**Interpretation IC 170-2008-10 of
ANSI/ASHRAE Standard 170-2008
Ventilation of Health Care Facilities**

Date Approved: January 21, 2014

Reference: This request for interpretation refers to the requirements in ANSI/ASHRAE/ASHE Standard 170-2008, Section 7 and Table 7-1, regarding to ER Waiting and Radiology waiting rooms.

Figure 1 – Outside air ACH of all cases, using both standards.

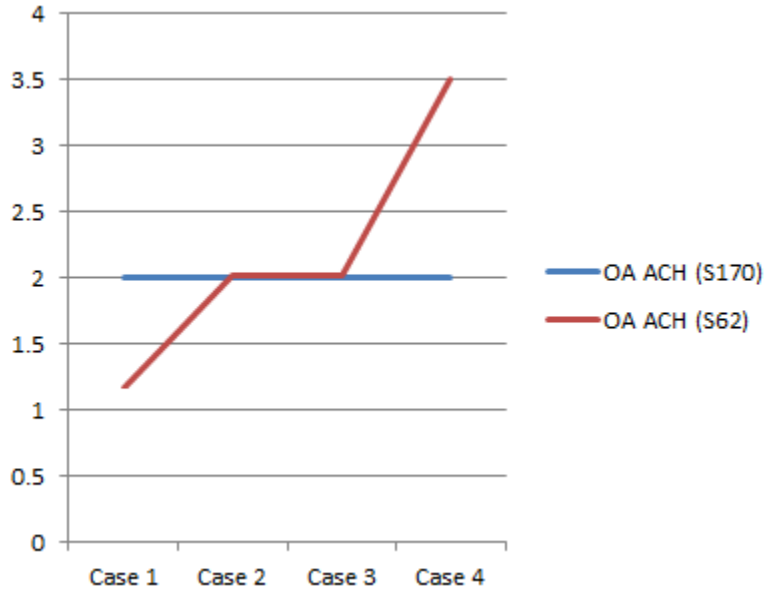
Resultant outside air flows, in ACH, are shown in **Figure 1** below. Air change per hour is constant using S170. ACH rate increases from case 1 to case 4 using S62.1.

Figure 2 – Cfm per person of all cases, using both standards.

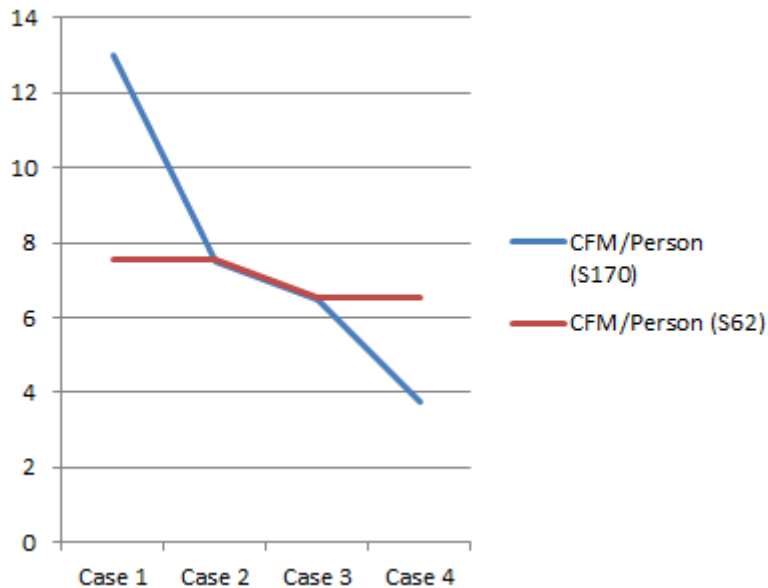
Resultant outside air flows, in cfm per person, are shown in **Figure 2** below. Cfm per person is fairly constant using S62.1. It decreases from case 1 to case 4 using 170.

Figure 3 – Percent difference between S170 and S62.1 outside air cfm per person

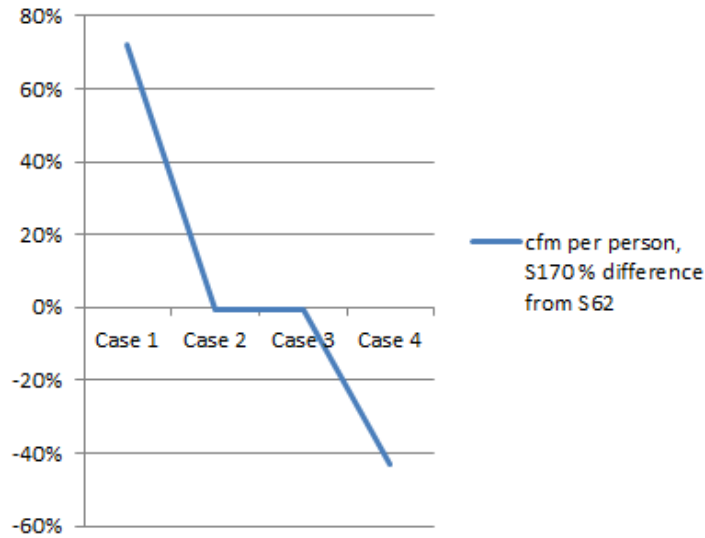
The percent difference in cfm per person required by each standard is shown in **Figure 3** below. For cases 2 and 3, the standards are aligned. Using S170, case 1 requires *72% more outside air*

than S62.1. This will increase energy the need for humidity control in the space. Using S170, case 4 requires 43% less outside air than S62.1. The fully occupied room would not have minimumally acceptable indoor air quality, as defined by S62.1.
